HISTORIC PRESERVATION BOARD MEETING

**PUBLIC HEARING
58 FORE STREET, PORTLAND COMPANY HISTORIC DISTRICT**

TO: Chair Sheridan and Members of the Historic Preservation Board
FROM: Deb Andrews, Historic Preservation Program Manager
DATE: February 25, 2020
RE: March 4, 2020 **PUBLIC HEARING**

Application for: Approval of outstanding design details and specifications for
Building 12, 1A and Grand Stairs

1 BUILDING 12 - NORTHEAST ELEVATION
SCALE: 1/4" = 1'-0"

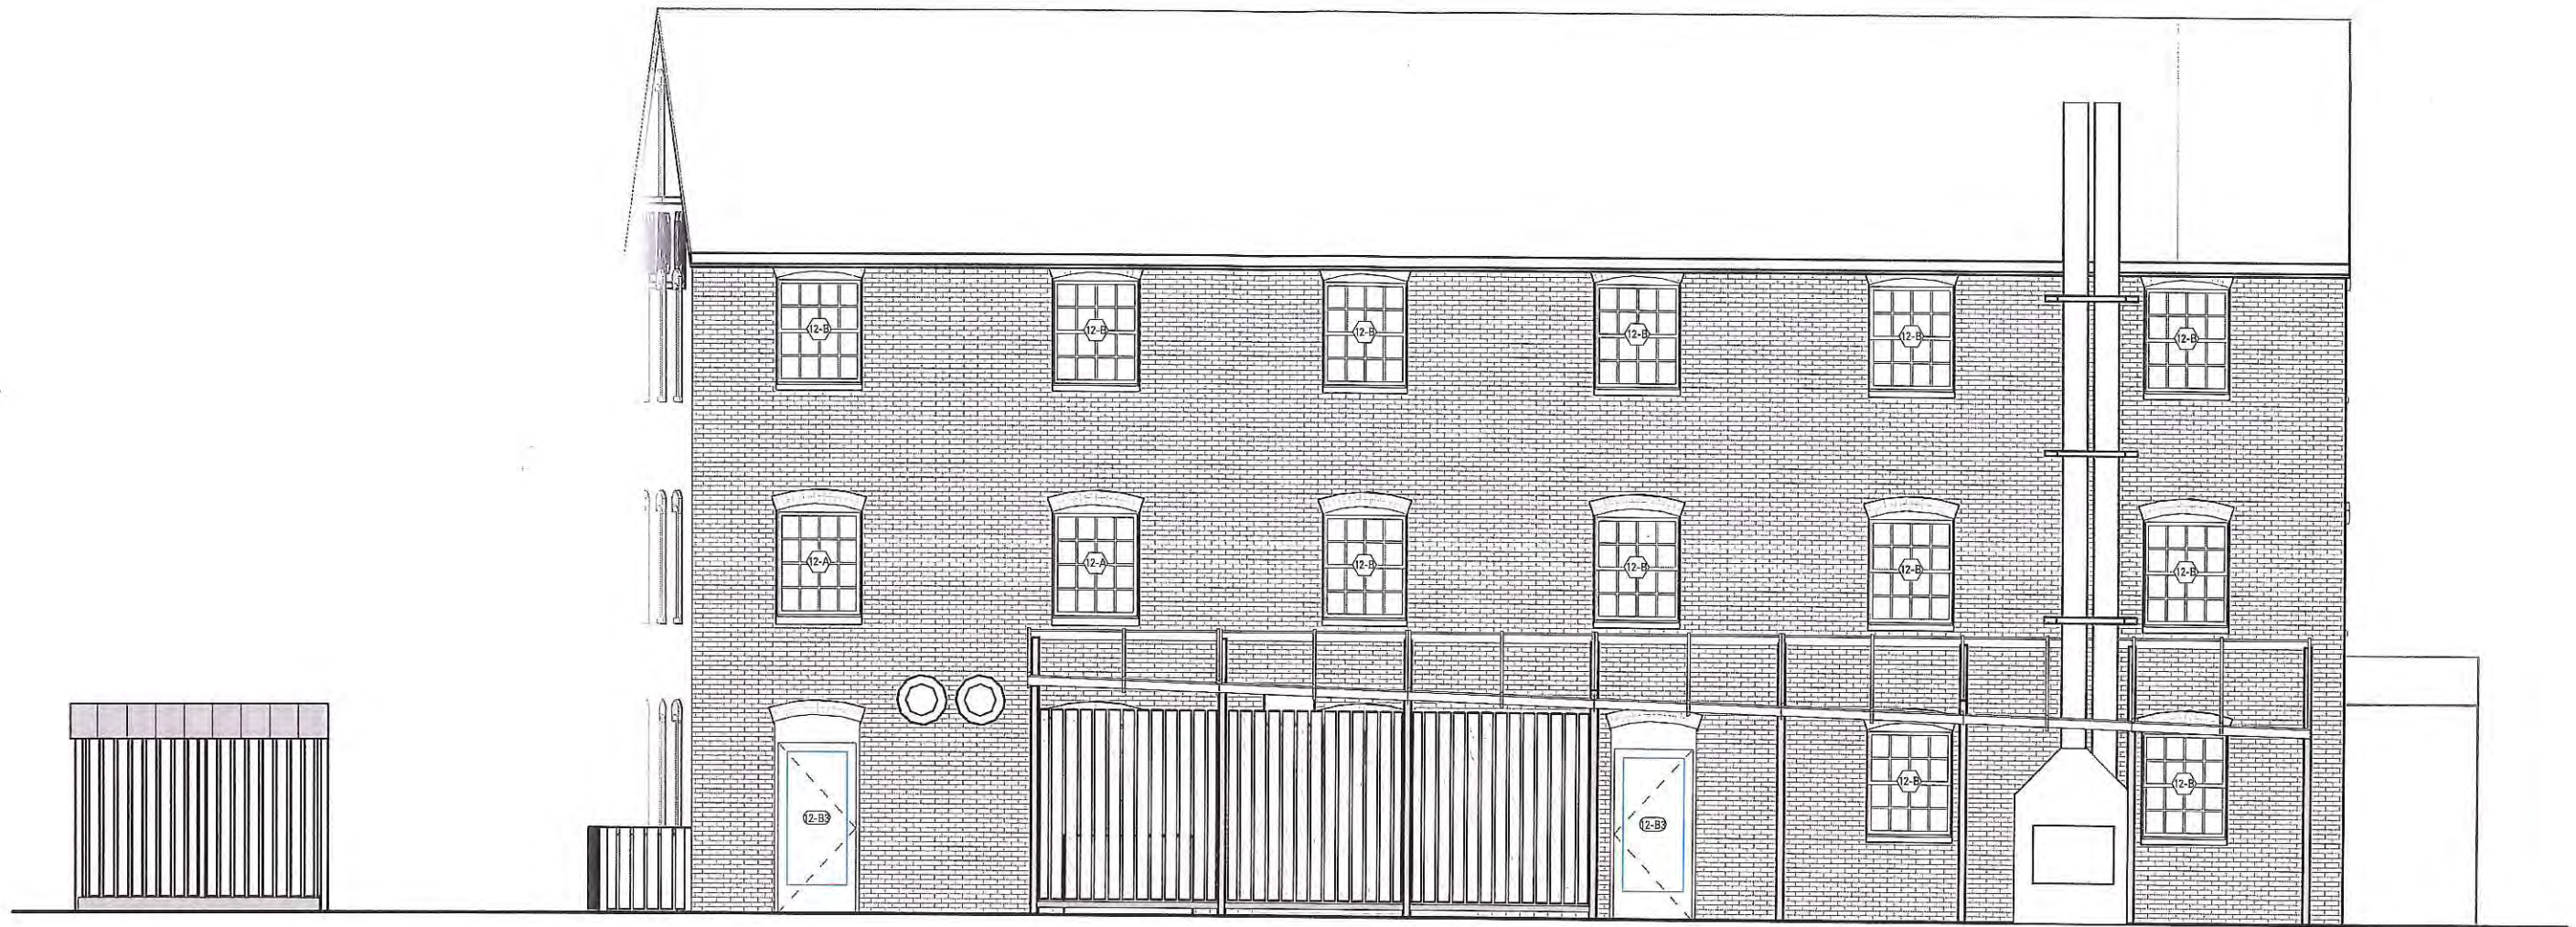
Note that there have been some minor changes to the plans since it was approved last September. Comparing original (ATT. 5) and current elevations, staff notes the following adjustments on the south elevation:

PROPOSED ROOF PLAN

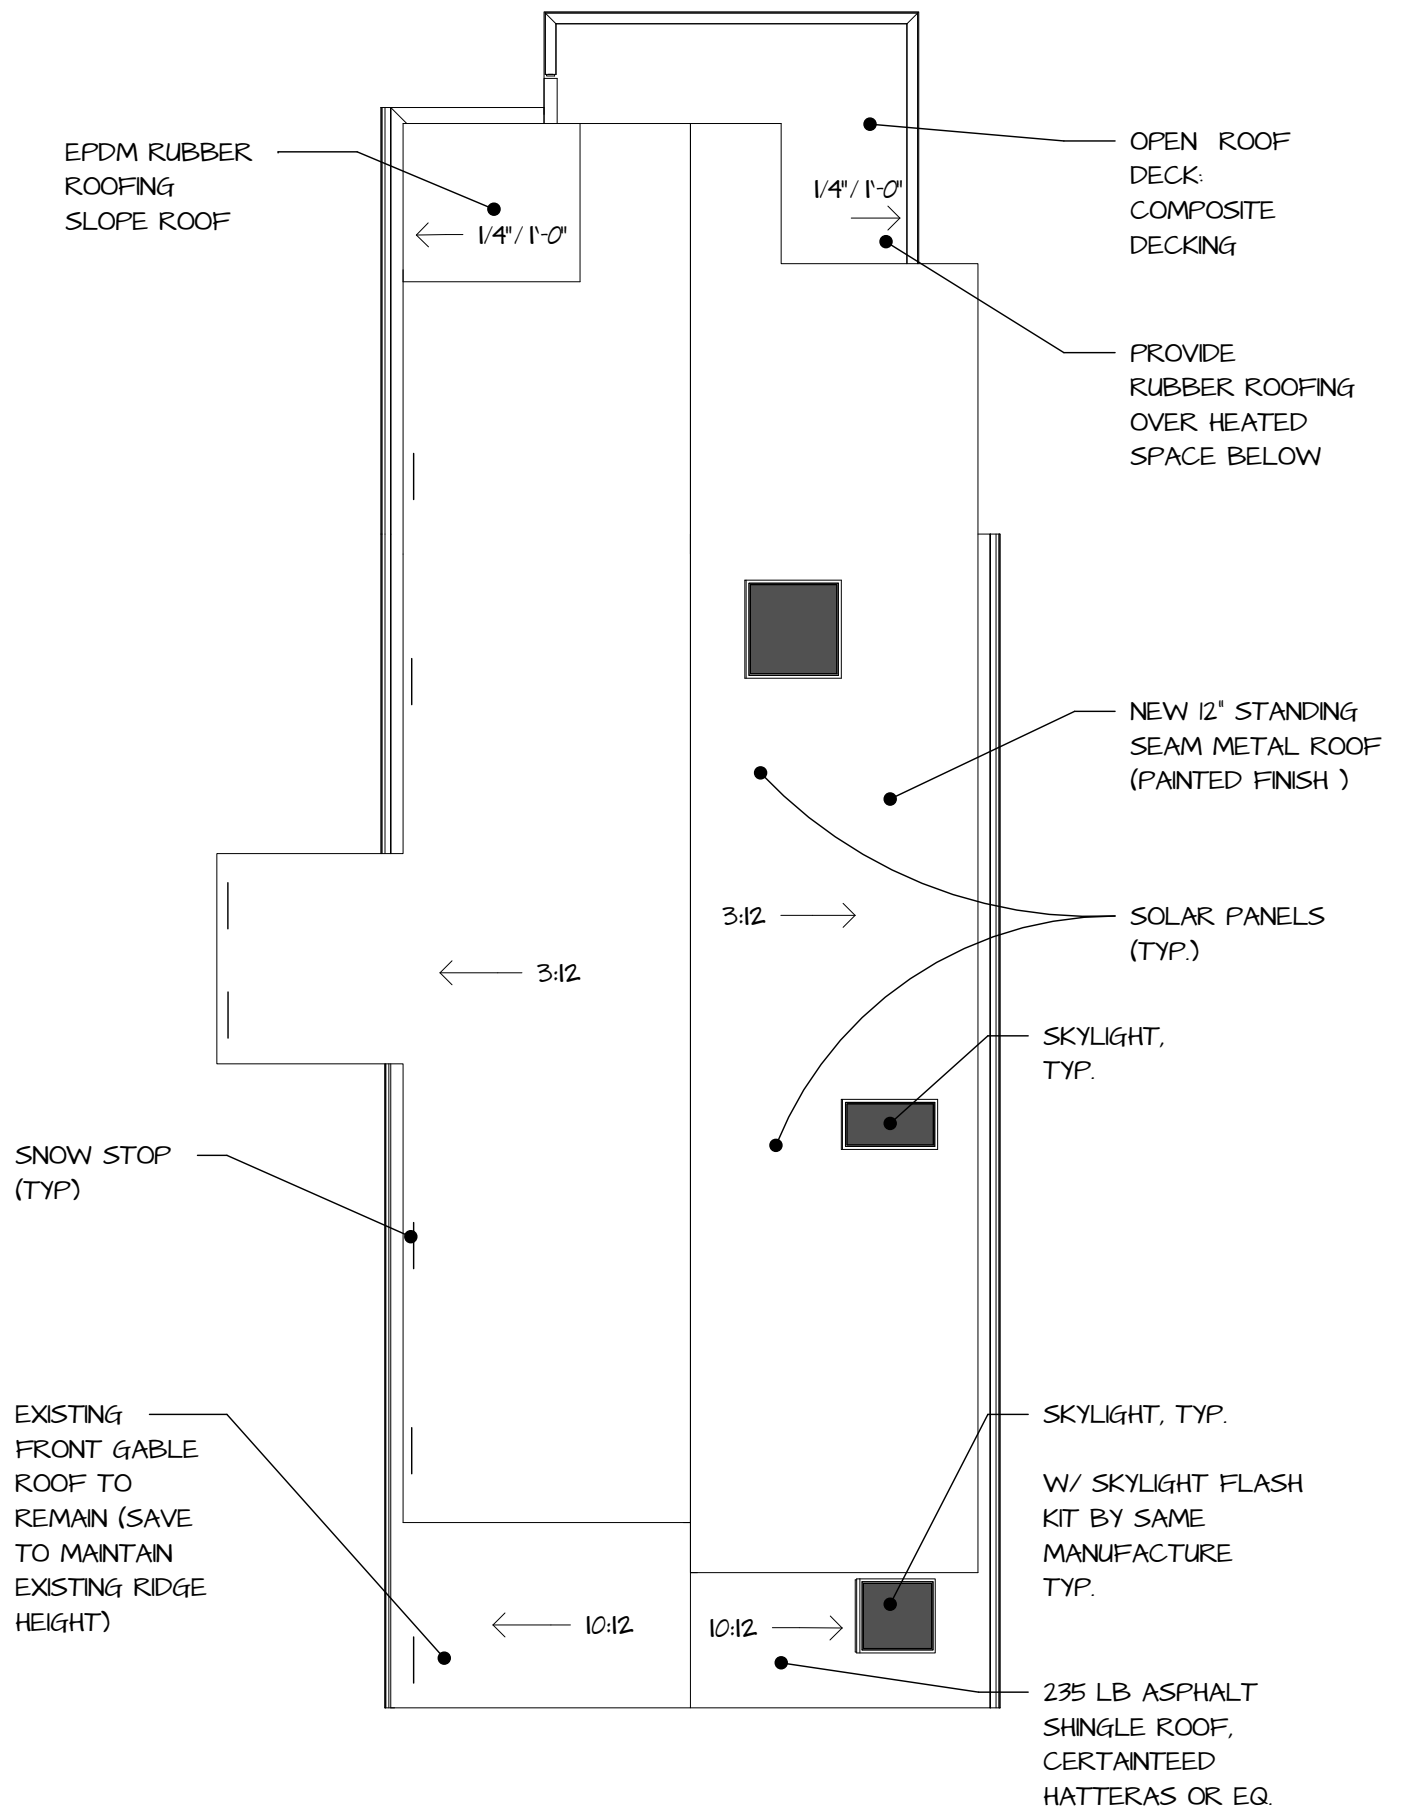
- While not opposed to continuous solar panels on both roof planes, staff questions the relative production value of those on the north-facing roof plane.

- Given the number of additions being introduced to the original roof, staff suggests that perhaps the skylight shown immediately in front of the dormer on the south-facing roof plane be eliminated. Eliminating this skylight, which lights a stairwell, would reduce the number of added elements and help calm the overall composition.
